**SOLICITATION AMENDMENT**

<b>Title - Sujet</b> Prescott Compressor	
<b>Solicitation No. - N° de l'invitation</b> F7047-180140/A	<b>Amendment No. - N° modif.</b> 004
<b>Client Reference No. - N° de référence du client</b> F7047-180140	<b>Date</b> 2019-02-26
<b>GETS Reference No. - N° de référence de SEAG</b> PW-\$ERD-005-27169	
<b>File No. - N° de dossier</b> 005erd.F7047-180140	<b>CCC No./N° CCC - FMS No./N° VME</b>
<b>Solicitation Closes - L'invitation prend fin</b> <b>at - à 02:00 PM</b> <b>on - le 2019-03-07</b>	
<b>Time Zone</b> <b>Fuseau horaire</b> Eastern Standard Time EST	
<b>F.O.B. - F.A.B.</b> <b>Plant-Usine:</b> <input type="checkbox"/> <b>Destination:</b> <input checked="" type="checkbox"/> <b>Other-Autre:</b> <input type="checkbox"/>	
<b>Address Enquiries to: - Adresser toutes questions à:</b> Richards, Shazia	<b>Buyer Id - Id de l'acheteur</b> 005erd
<b>Telephone No. - N° de téléphone</b> (613) 614-2383 ( )	<b>FAX No. - N° de FAX</b> ( ) -

#### **Amendment 004**

This amendment is raised to extend the solicitation closing date and to publish questions and answers.

*Figure 1: Location of tie in flange to remainder of compressed air system*

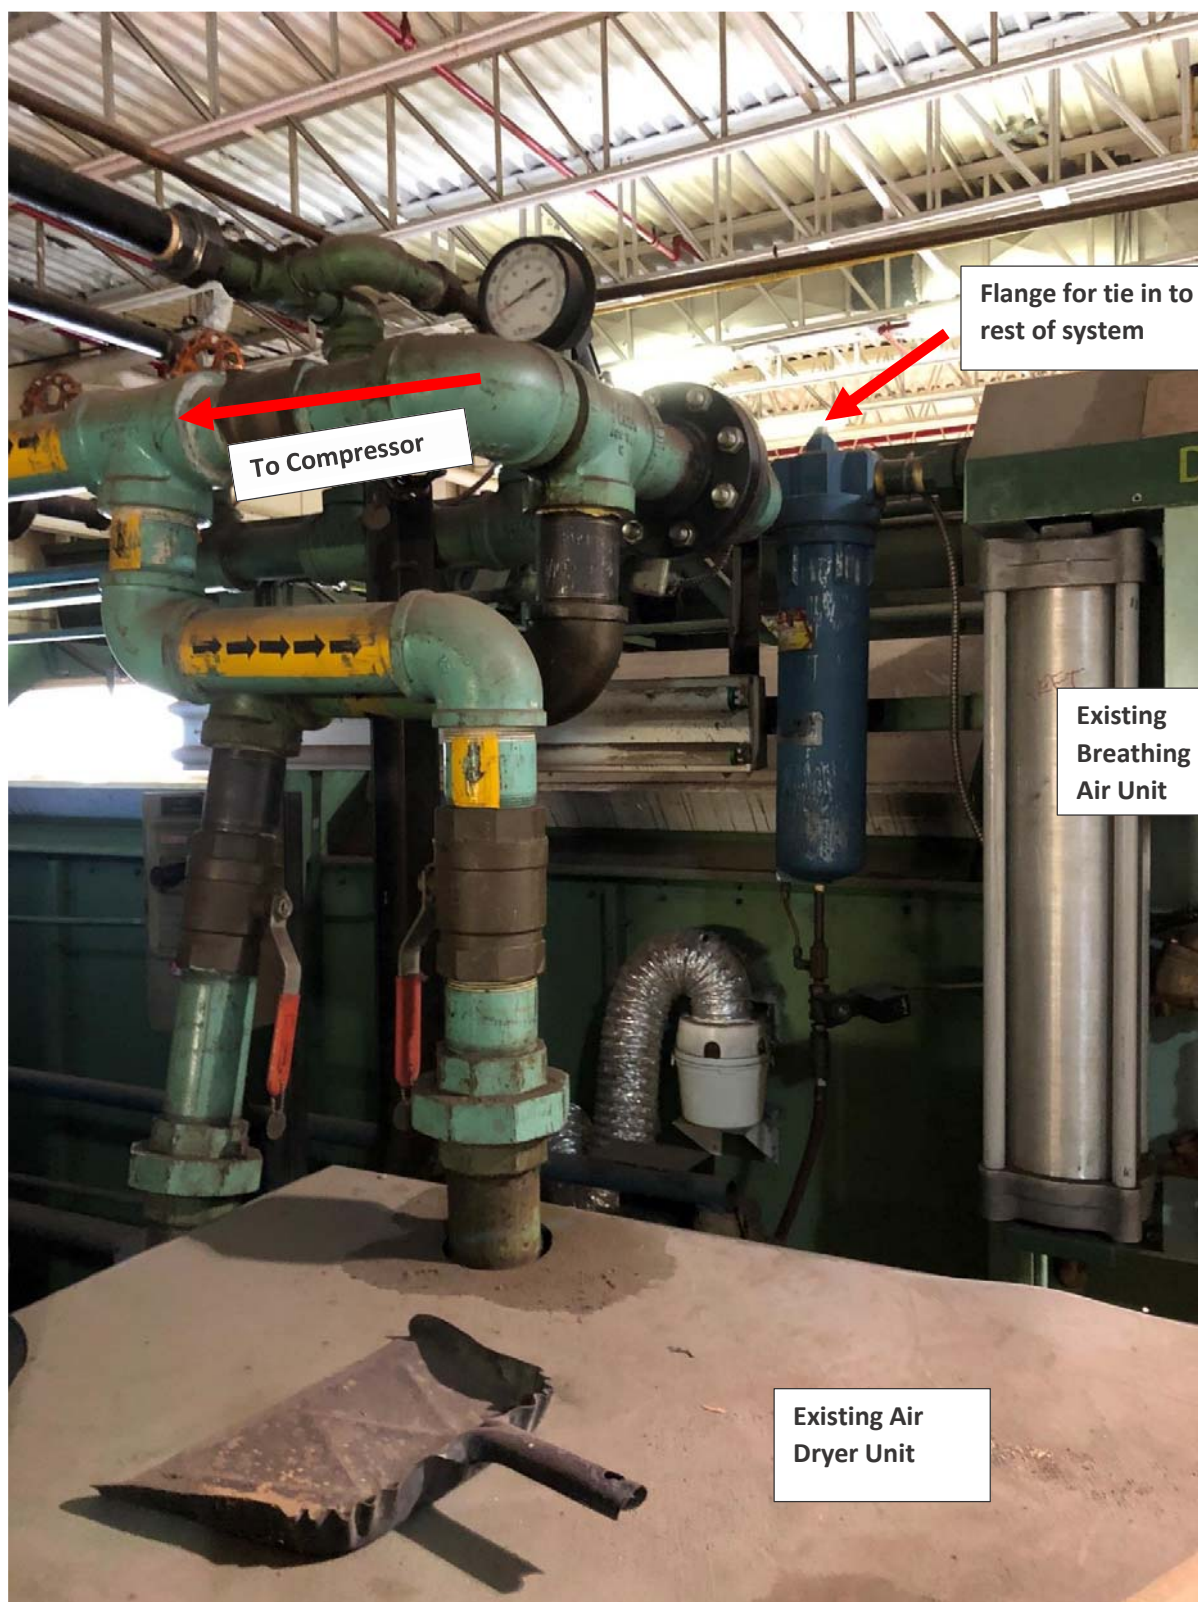
**Question 11:** Where is the Contractor required to tie into the existing piping system?

**Response 11:** The Contractor is expected to tie into the system at the connecting flange shown in Figure 1. Unfortunately, there are no as-built piping drawings available. All piping not required in the new compressor system upstream of the flange tie in are to be removed and disposed of.

**POWER, LIGHTING & SYSTEMS LAYOUT**

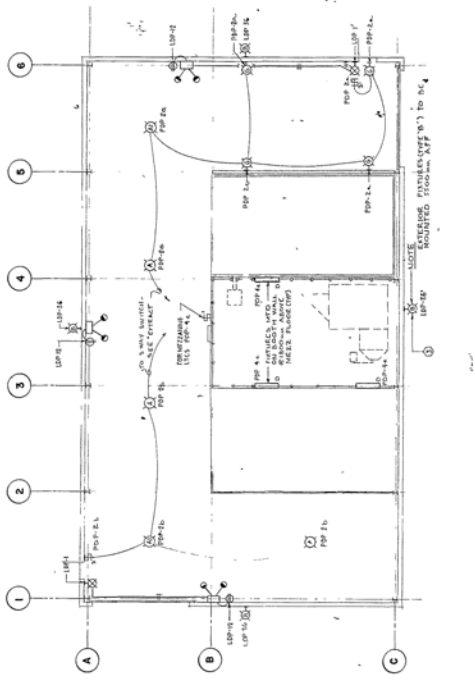
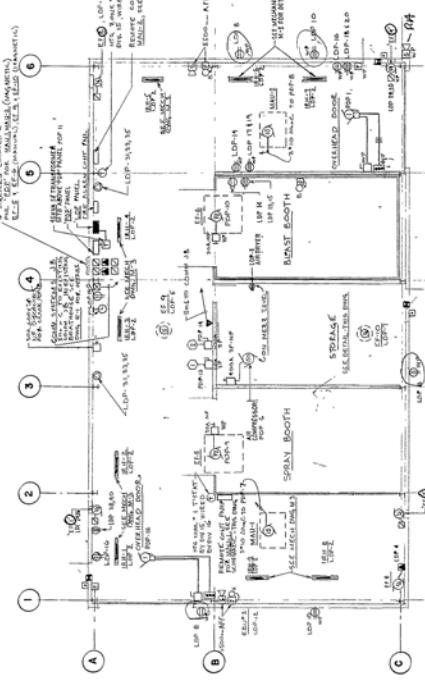
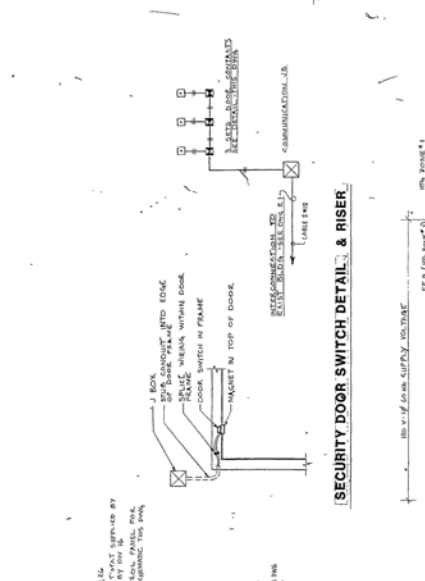
**Question 16:** Does the electrical installation need to be wired back to the disconnect or the breaker panel?

**Question 25:** What panel is the compressor fed from? What is the breaker load?

**Response 16:** The new compressor just needs to be wired into the disconnect. Please reference attached drawing 701622-E2 and 701622-E3.

**Response 25:** The compressor is fed from panel "LDP" reference drawing 701622-E2. Note the current breaker is 250A (Figure 3) and not the 350A as listed on the drawing.
